TAL-CO SUPPLEMENTAL INSTRUCTION #26			
Project Name:	RW TOMLINSON - NEW HEAD OFFICE		
Project Location:	100 City Gate Drive, Ottawa, Ontario		
ARCH. SI #:	ASK # 65	Issued By:	Chris Simpson
STRUC. SI #:	SSI #15 R1	Date Issued:	February 13, 2017
MECH. SI #:	N/A	Revision #:	N/A
ELEC. SI #:	N/A	Revision Date:	N/A

**Title:** Detailing of retaining wall near Grid 1 between G and J.

STRUCTURAL SITE INSTRUCTION No.: 015R01

PROJECT: TOMLINSON NEW BUILDING	DATE: 2017/01/23
	SCALE: 1:100
	DRAWN BY: JK
DRAWING TITLE: REFERENCE PART OF 1/A111	JOB No: 574-15
	DRAWING No: <b>ASK-65</b>

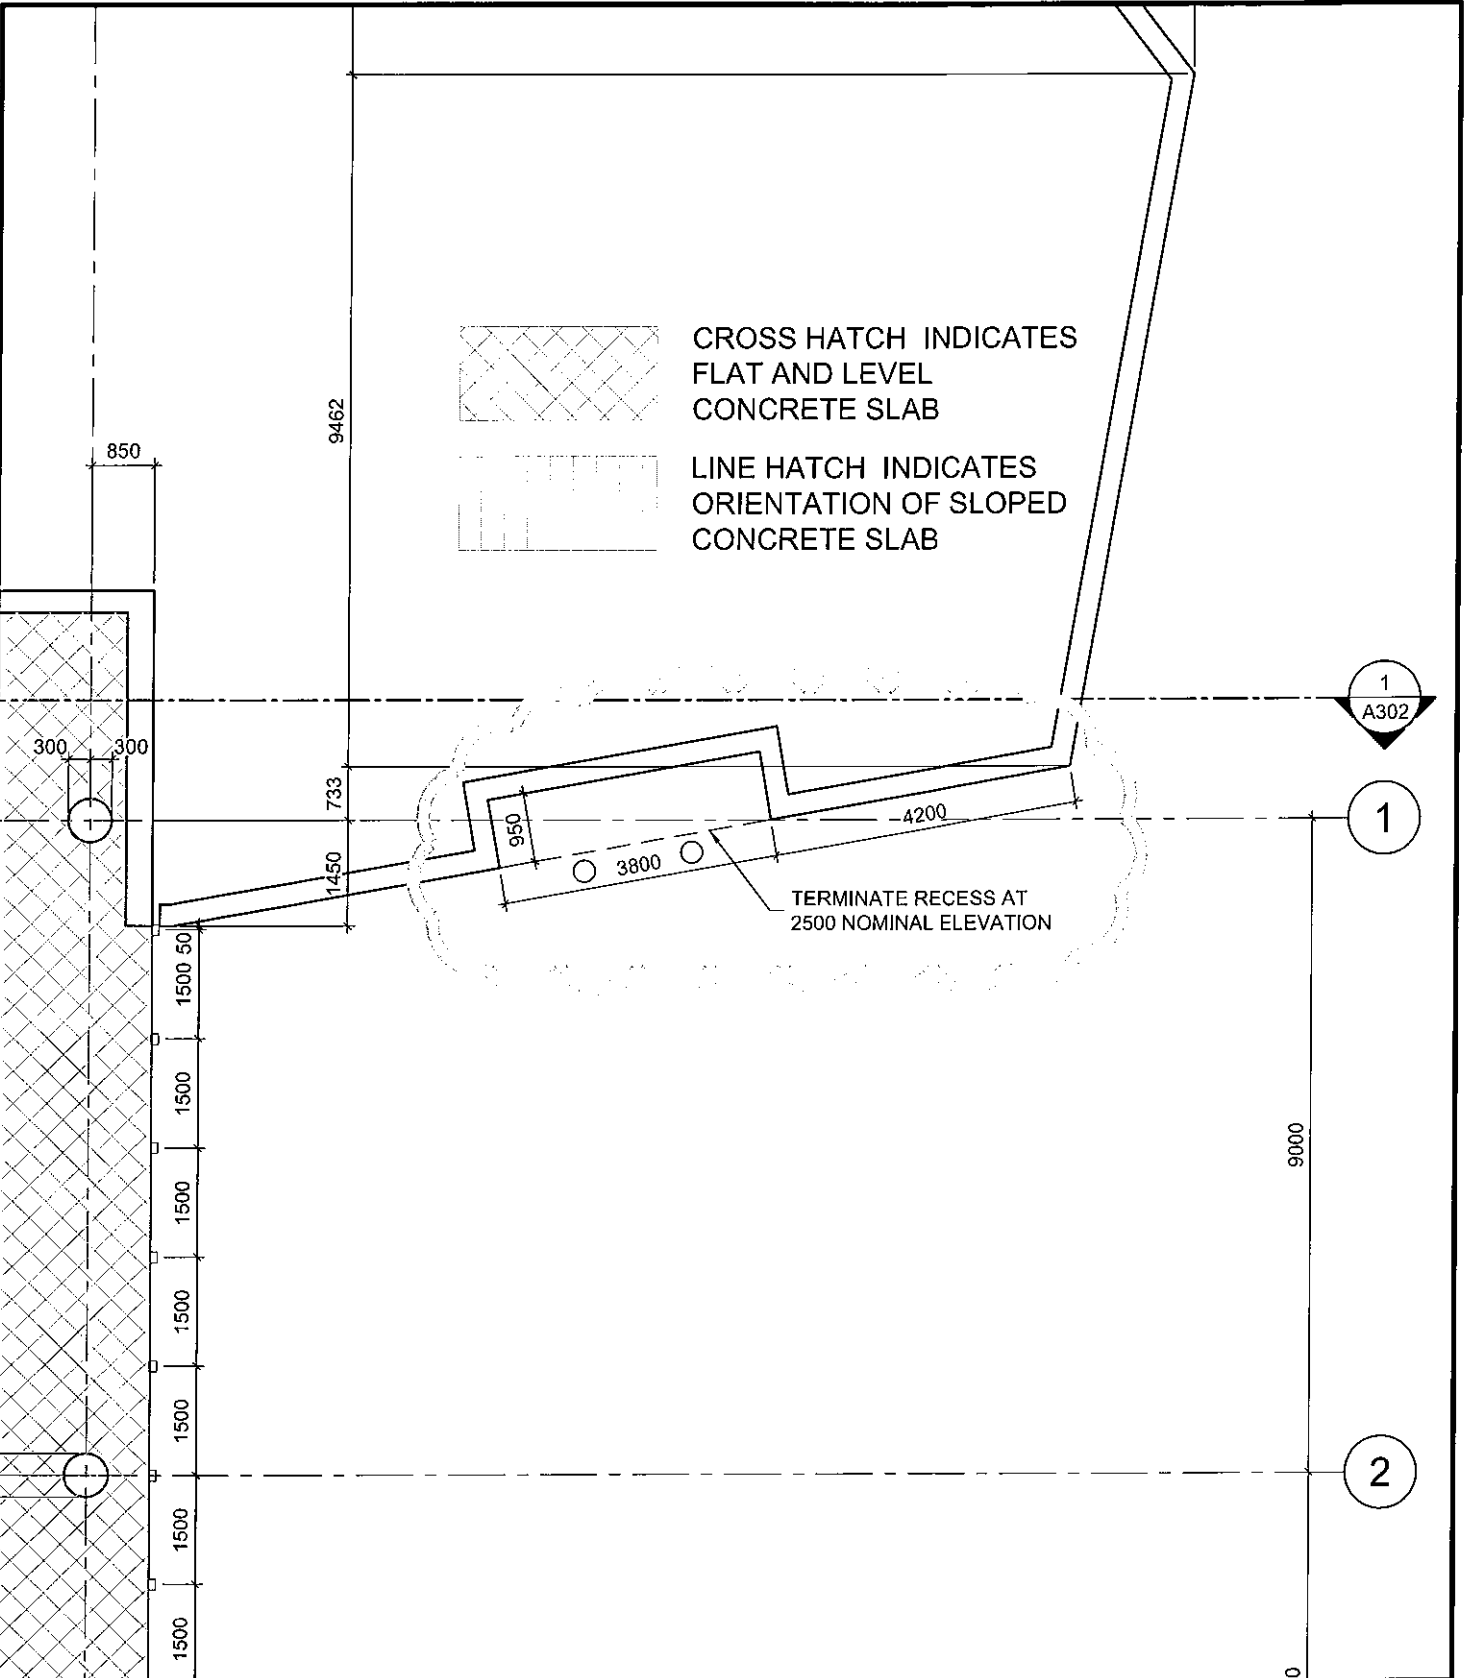
**Description of the Work:** This retaining wall has been detailed to add a recessed niche to house the Enbridge Gas meter.

TERMINATE RECESS AT  
2500 NOMINAL ELEVATION

SECTION: RETAINING WALL @ GAS METER NOTCH.

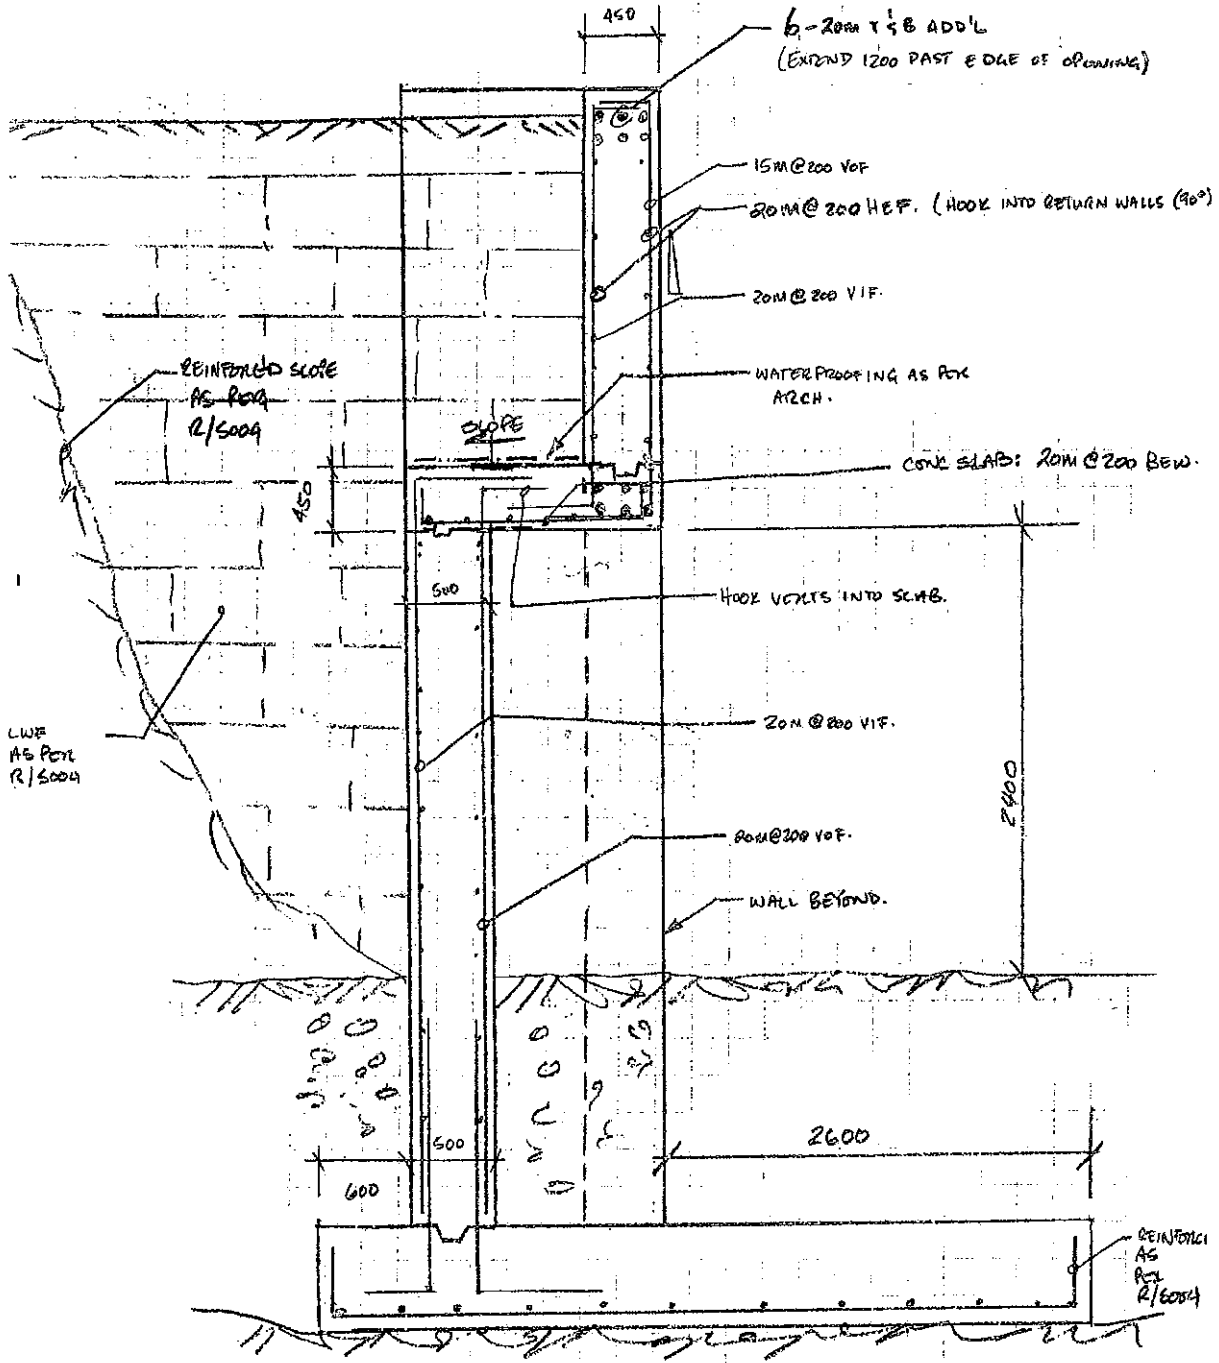
**Information to be Clarified:**  
Contractor is to refer to attached sketch for retaining wall footings.
